RE: **PUBLIC** Comments of the Minnesota Department of Commerce
Docket No. E002/M-25-142

In the Matter of Xcel Energy's 2025 Integrated Distribution Plan.

Xcel Energy's (Xcel or the Company) Integrated Distribution Plan (IDP) was filed on October 31, 2025. Xcel's Transportation Electrification Plan was filed concurrently.

The Department recommends the Commission accept Xcel's IDP with additional requirements and is available to answer any questions the Minnesota Public Utilities Commission may have.

Figure 4: Xcel Presentation of Mandatory VS Discretionary Spending

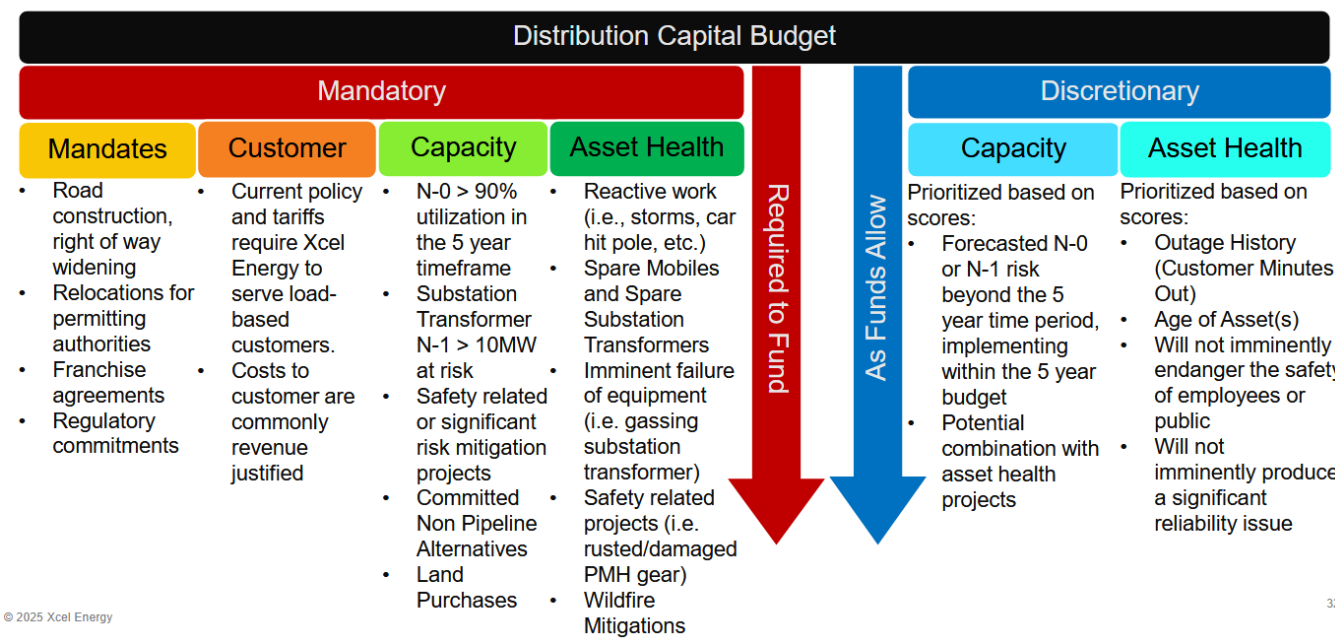
Xcel may counter that large portions of its system planning are not discretionary (Figure 4), which implies that these projects do not require optimization. While the Department does not question the validity of some mandatory spending shown in Figure 4, the Department disagrees on Xcel’s use of the term “mandatory.” Upstream decision making before budgeting, such as decisions made in forecasting, capacity planning limits, the benefits of reliability, and wildfire mitigations all involve judgment and choice. As the Department will demonstrate in these comments, there is a strong need to evaluate whether Xcel’s system planning decisions are in the public interest.

Figure 6: Comparison of Actual Feeder Capacity to Xcel's N-0 Capacity Planning Standard

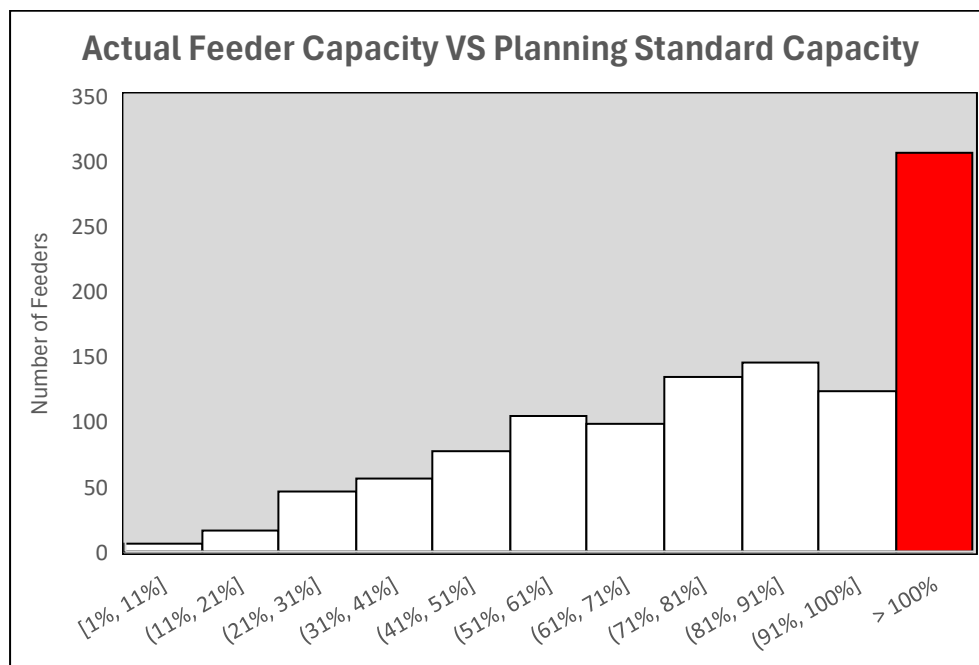
While Xcel may argue that these planning standards cannot be modified, these assertions are easily refuted by Xcel's own data. Figure 6 shows that 27 percent of Xcel's existing feeders are currently exceeding Xcel's planning standard, which indicates that the Company decided to not fully enforce its own planning standards.

Figure 10: Trend in Xcel Distribution Spending Over Time

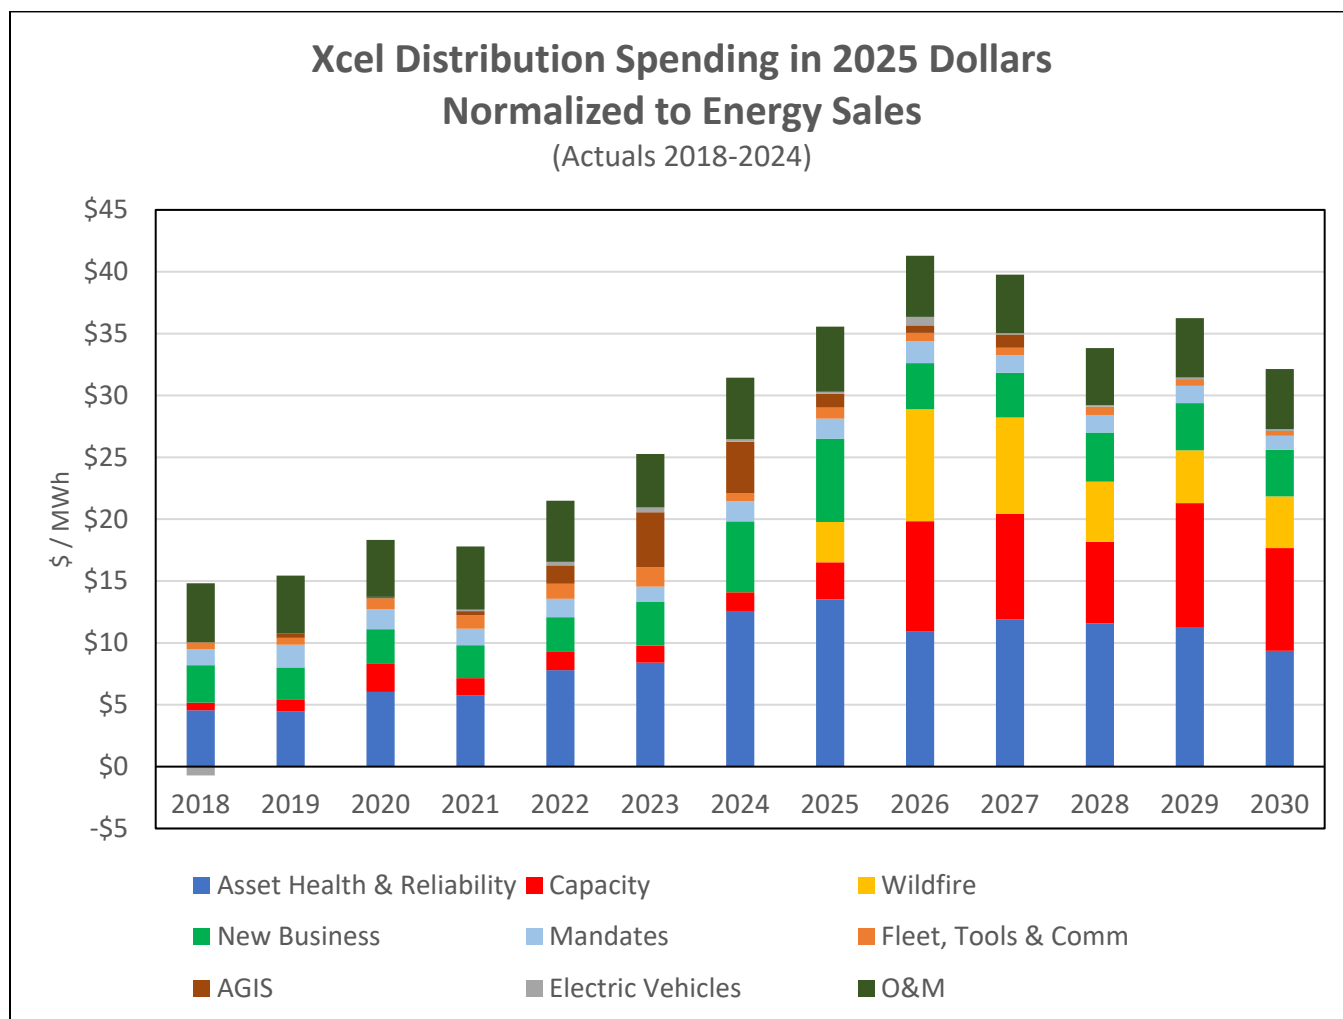
Figure 10 shows Xcel's distribution spending in 2025 dollars, normalized to energy sales and covering the years 2018 to 2030. Xcel's distribution spending for the years 2018 through 2024 are based on actual budget expenditures and the data for the years 2025 through 2030 are based on forecasted budget expenditures. The greatest spending increases occur in the following three spending categories: Asset Health and Reliability, Capacity, and Wildfire Mitigation.

Figure 11: Xcel Asset Health & Reliability Spending Adjusted to Energy Sales

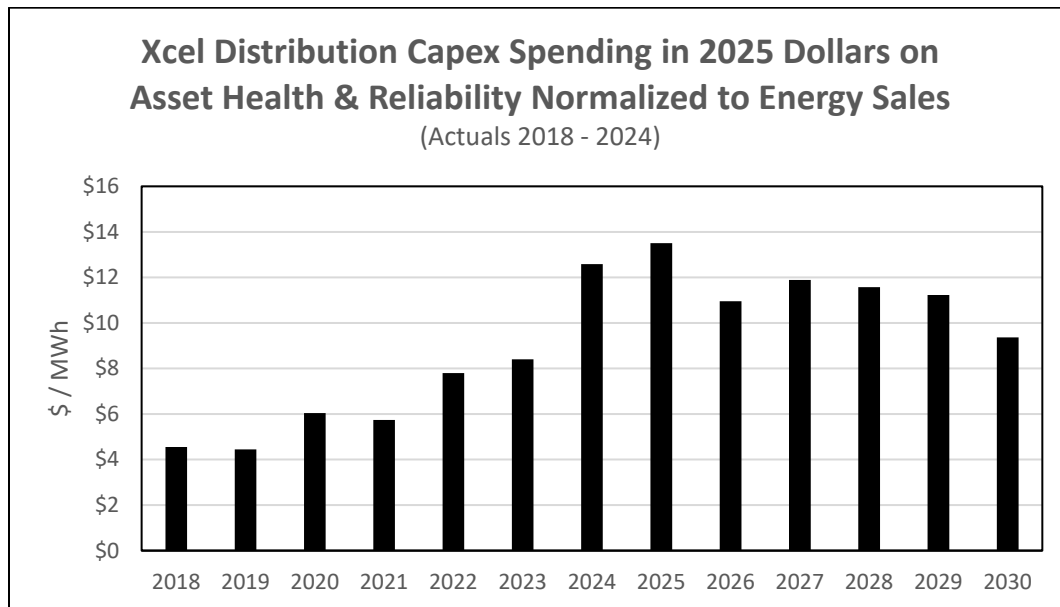
Asset Health and Reliability is Xcel's largest budget category. Figure 11 shows Xcel's Asset and Reliability spending, in 2025 dollars, normalized to energy sales and covering the years 2018 to 2030. The Xcel Asset and Reliability spending for the years 2018 through 2024 are based on actual numbers and the data for the years 2025 through 2030 are based on forecasted numbers. Figure 11 shows the recent jump in spending on Asset Health and Reliability and the forecasted higher level of spending for the next several years. Spending was stable from 2018 through 2021, began an upward climb during the years 2022 and 2023, and then jumped in 2024 to a much higher forecasted level through 2030. Xcel's actual historical Asset Health and Reliability budget, for the years 2020 through 2024 (in 2025 dollars), totals \$1.09 billion. Xcel's total forecasted Asset Health and Reliability budget, for the years 2026 through 2030 (in 2025 dollars), grows to a total of \$1.47 billion. This data shows an increase of 35% from the total historical Asset Health Reliability budget for the 2020 to 2024 period to the forecasted Asset Health and Reliability budget for the 2026 to 2030 period.

Figure 13: Xcel Wildfire Spending Adjusted to Energy Sales

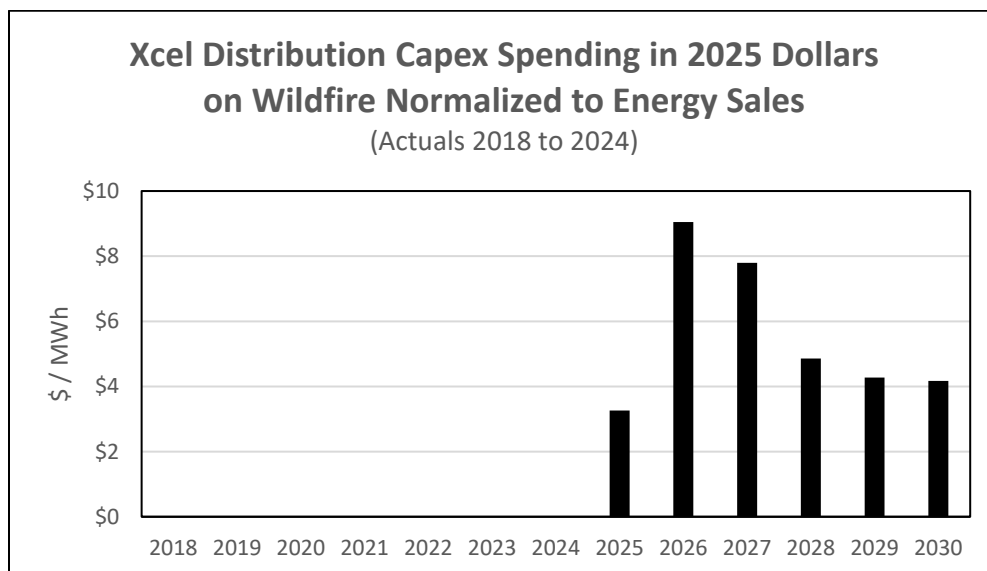
Figure 13 shows these trends in Wildfire spending, in 2025 dollars, normalized to energy sales covering the years 2018 to 2030. The Xcel Wildfire spending for the years 2018 through 2024 are based on actual numbers and the data for the years 2025 through 2030 are based on forecasted numbers. Xcel did not allocate funding to Wildfire Mitigation from 2018 through 2024. However, it is forecasted to increase significantly in 2025, then to jump in 2026 and stay at a higher level until 2030, as shown in Figure 13. Xcel's actual historical Wildfire budget, for the years 2020 through 2024, totals \$8 million (in 2025 dollars). Xcel's total forecasted Wildfire budget, for the years 2026 through 2030 (in 2025 dollars), grows to a total of \$803.05 million.

Figure 17: Number of Feeders That Exceed the 75% Capacity Planning Standard: 2019–2029

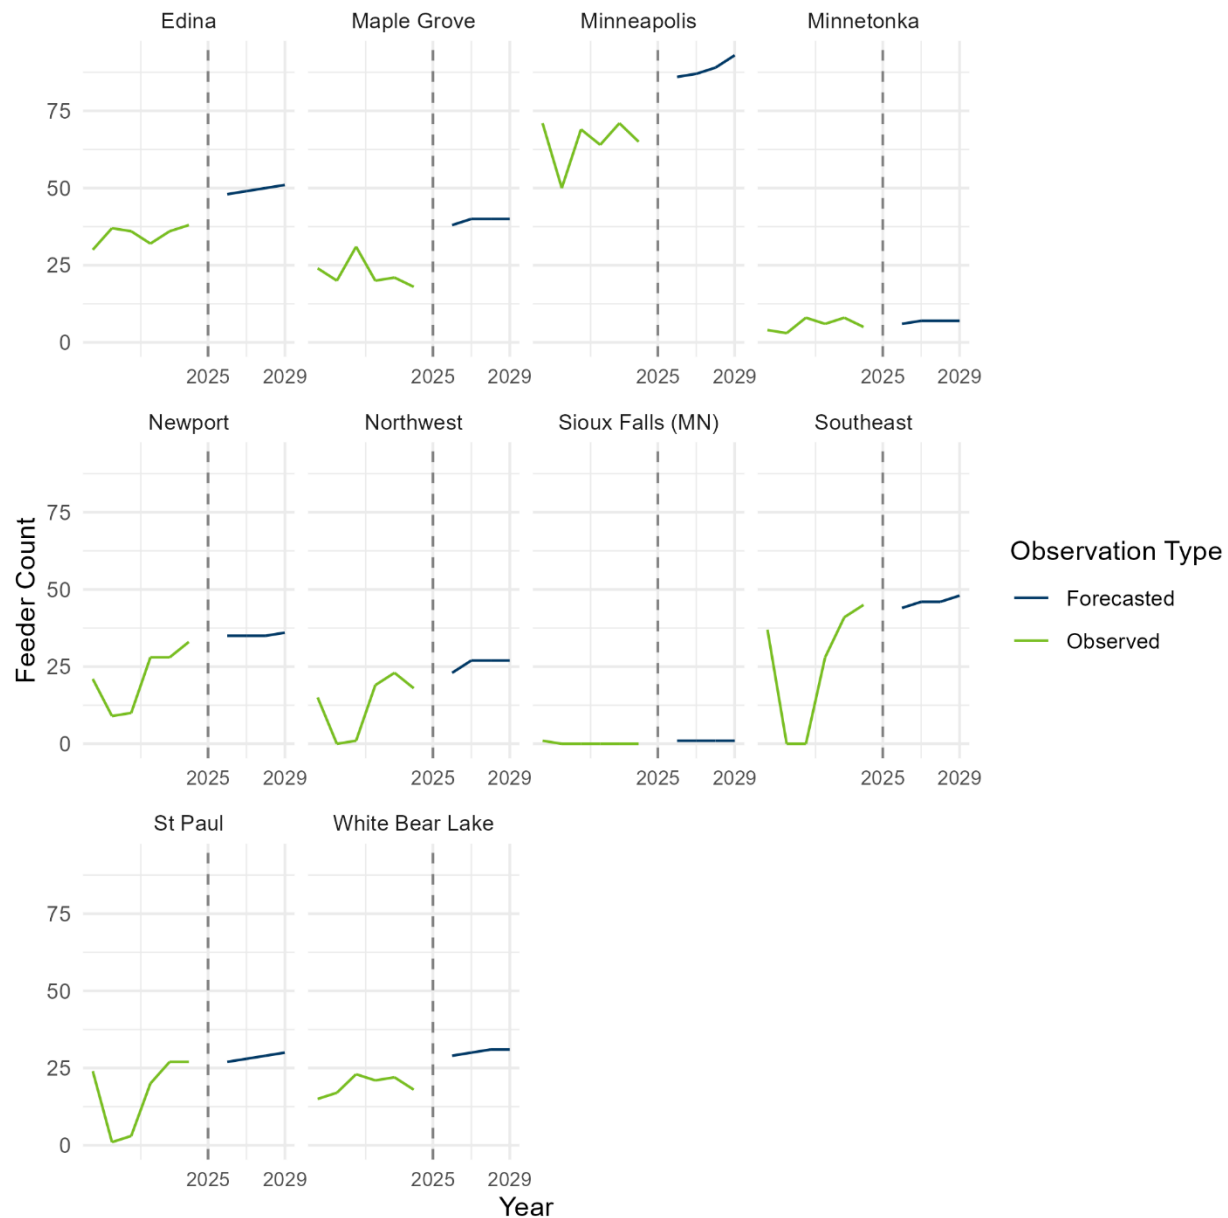
disaggregated by Planning Division. This figure indicates that capacity constraints are not evenly distributed across the system; certain PDs consistently exhibit higher numbers of heavily loaded feeders.

These patterns raise important questions about the underlying causes of forecasted rise in feeder congestion and whether capital investments are efficient. While most planning divisions show observable trends in Figure 17, Edina, Maple Grove, Minneapolis, and White Bear Lake all show visible

Figure 19: Projected Increase in Heating Load by Planning Division

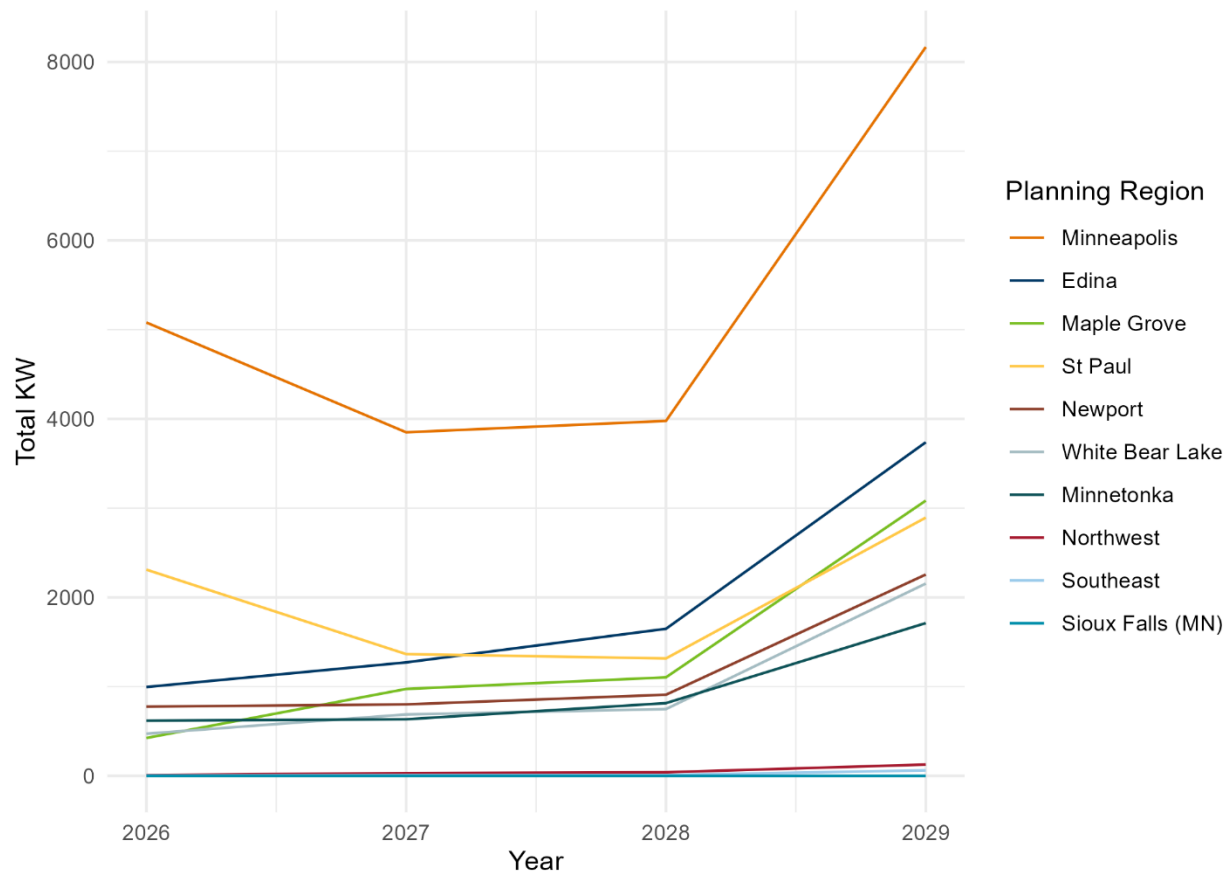
For example, in Minneapolis, forecasted heating-related peak load is projected to approximately double within a two-year period. Similarly, EV-related peak load increases sharply in multiple PDs over the forecast horizon. While electrification is an expected long-term trend, the magnitude and timing of these increases raise questions about the underlying assumptions driving the Company's forecasts.

Figure 24: Actual Feeder Loading Compared to Rated Capacity

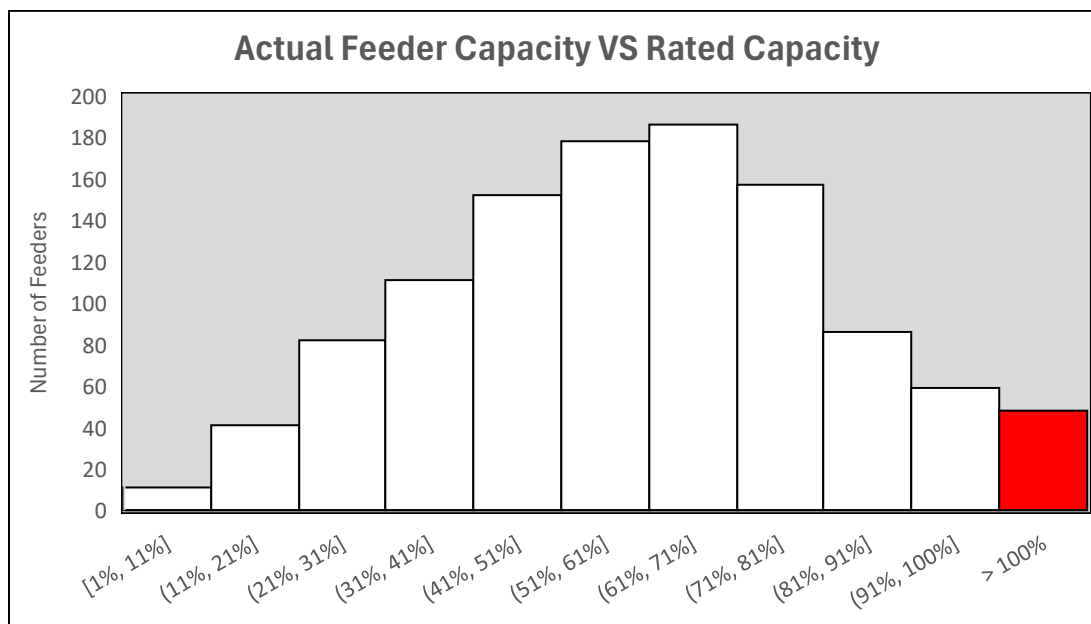
Xcel's feeder capacity data reflects a similar pattern, where 3.2% of feeders are currently overloaded, as shown in Figure 24.
